15216 – Propshaft U-joint Retainer Bolts Loss of Index

2015 Cadillac Escalade, Escalade ESV

Equipped with 6.2L Engine (RPO L86) and 8-speed Automatic Transmission (RPO M5U)

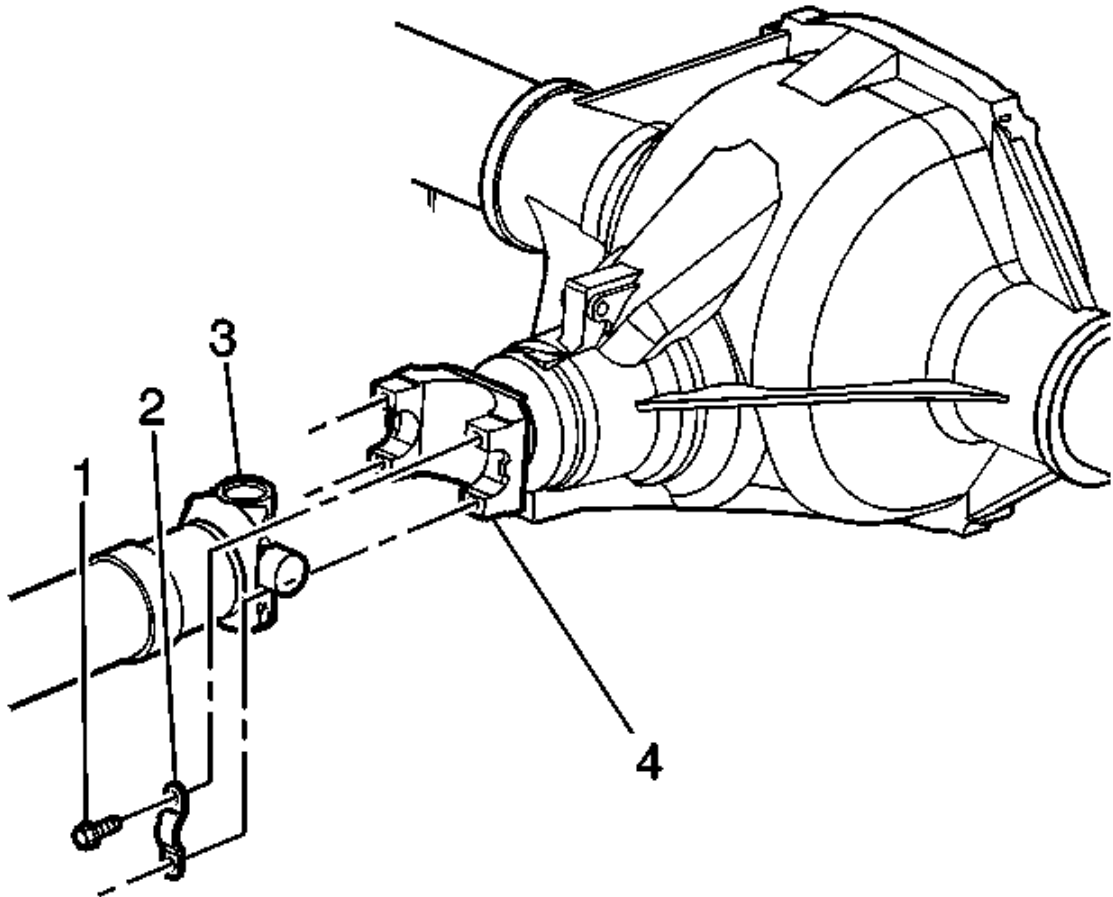
Dealers are to replace two u-joint retainers and four u-joint retainer bolts with new bolts. The new bolts include an adhesive patch for improved retention.

Remove the two u-joint retainers (2) and four u-joint retainer bolts (1). Refer to in SI.

3. Discard the two u-joint retainers (2) and four u-joint retainer bolts (1).

4. Install two new u-joint retainers (2) and four u-joint retainer bolts (1). Refer to in SI. Tighten bolts to **25 Nm (18 lb ft)**.
